***Docket Item #7 A-E - The Calvert Apartments  
Master Plan Amendment #2009-0005  
Rezoning #2009-0003  
Development Special Use Permit #2009-0006  
Transportation Management Plan #2010-0002  
Vacation #2009-0001***

Application	General Data	
<b>Project Name:</b> The Calvert Apartments  <b>Location:</b> 3110 Mount Vernon Avenue  <b>Applicant:</b> UDR Calvert, LLC Represented by Duncan Blair	PC Hearing:	September 7, 2010
	CC Hearing:	September 25, 2010
	If approved, DSUP Expiration:	September 25, 2013 (36 months)
	Plan Acreage:	3.41 acres 3.49 acres (with vacation)
	Zone:	CRMU-M
	Proposed Use:	Residential with retail
	Gross Floor Area:	Residential: 283,426 sf Retail: 10,914 sf Total: 294,340 sf
	Dwelling Units:	Existing: 187 Units Proposed: 332 Units
	Small Area Plan:	Potomac West
	Green Building:	Compliance with Green Building Policy – LEED Certification

Purpose of Application
Approval for redevelopment of the existing Calvert Apartments site with the addition of 145 new units. The proposal requires approval of the following applications: <ol style="list-style-type: none"> <li>1. Master Plan Amendment (to remove proffer) #2009-0005</li> <li>2. Rezoning (to remove proffer) #2009-0

**Attachment #1 – Revised Zoning Tabulations**

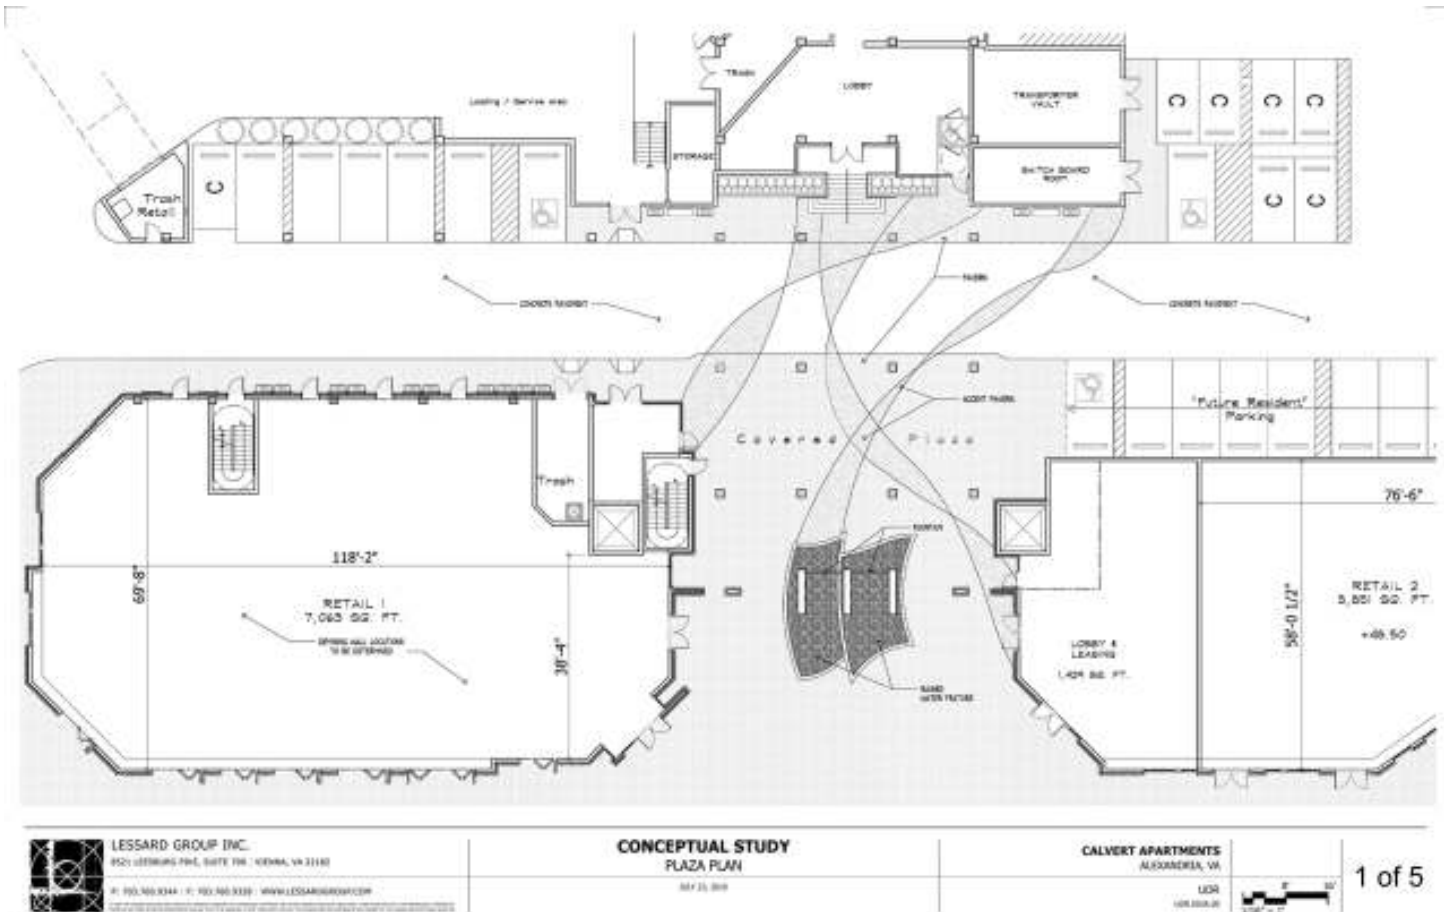
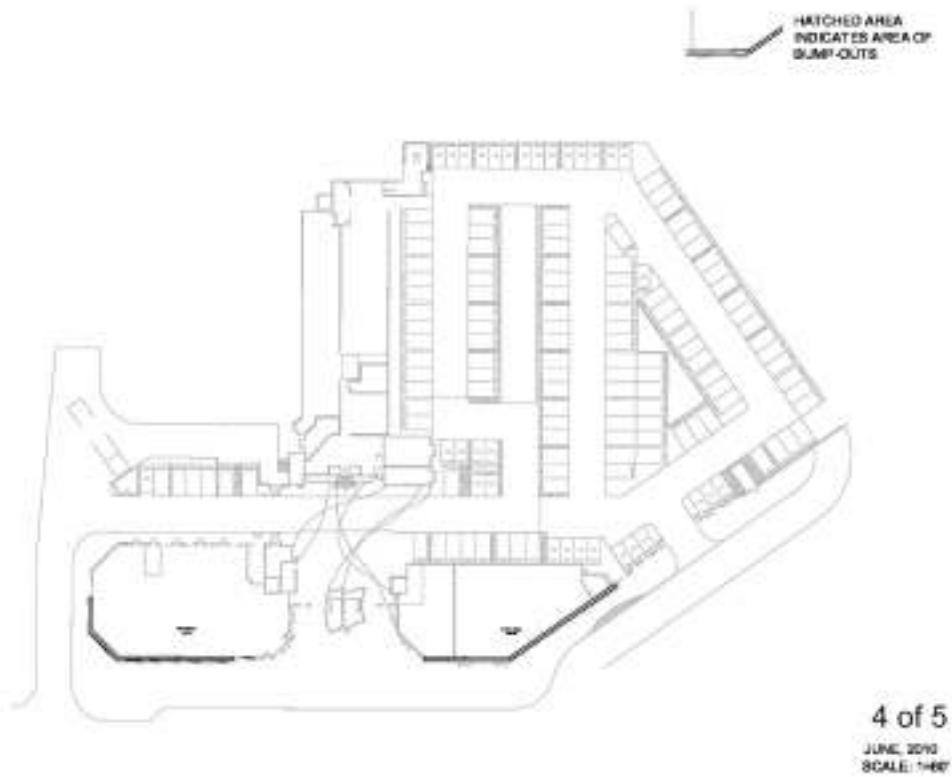
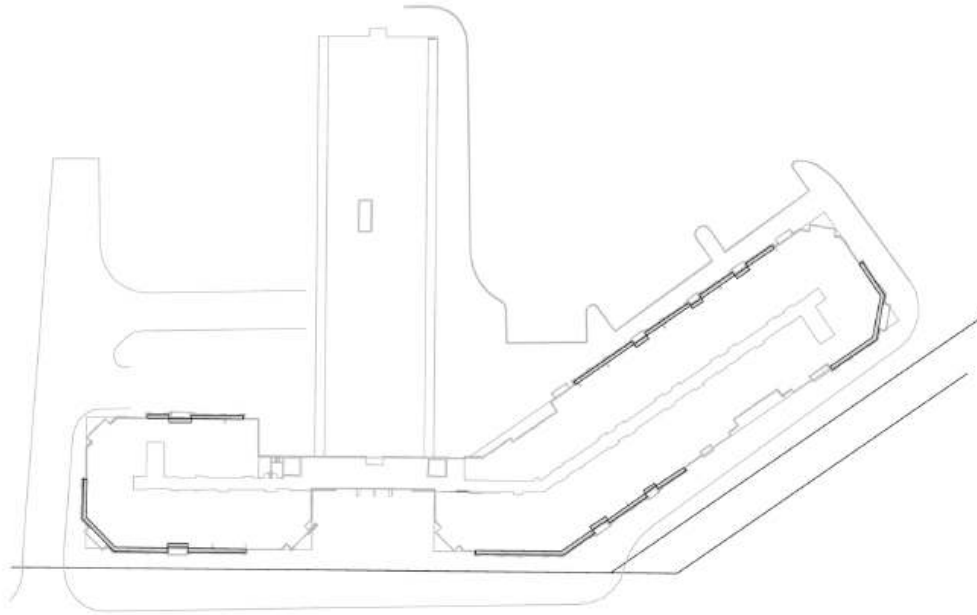
1. The Final Site shall be in substantial conformance with the preliminary plan dated December 17, 2009, as amended by the updated zoning tabulations (*Attachment #1*), the Conceptual Study Plaza Plan dated July 23, 2010 (*Attachment #2*), and revised elevations of the mid-rise building dated July 23, 2010 (*Attachment #3*), and shall comply with the following conditions of approval.
